New Model Introduction

New model GR-4200 is offered as a replacement for model GR-3520V. Models have common mounting and tooling and are dimensionally the same except as shown.

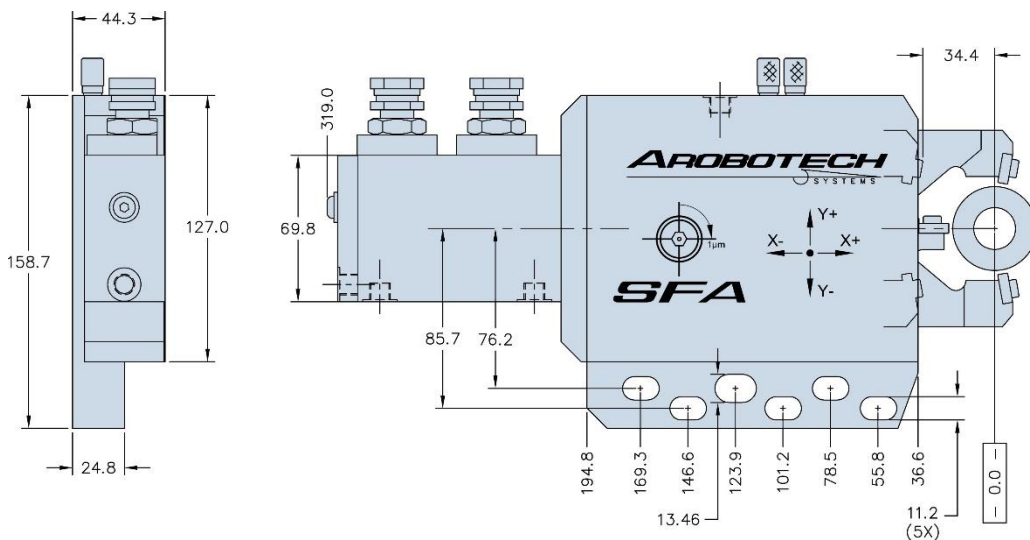
Gen 4 Model GR-3520V

- * 15 to 35mm Diameter
- * 6.4 cm² Piston Area
- * X-Axis = 3.1° Turn = 0.001mm Adjustment ▪ ±0.22mm Total Adjustment
- * Y-Axis = 10.4° Turn = 0.001mm Adjustment ▪ ±0.07mm Total Adjustment

Gen 5 Model GR-4200

- * 15 to 40mm Diameter
- * 6.4 cm² Piston Area
- * 90° Turn = 0.001mm Adjustment (both axis)
- * +/- 0.200mm Total Adjustment (both axis)
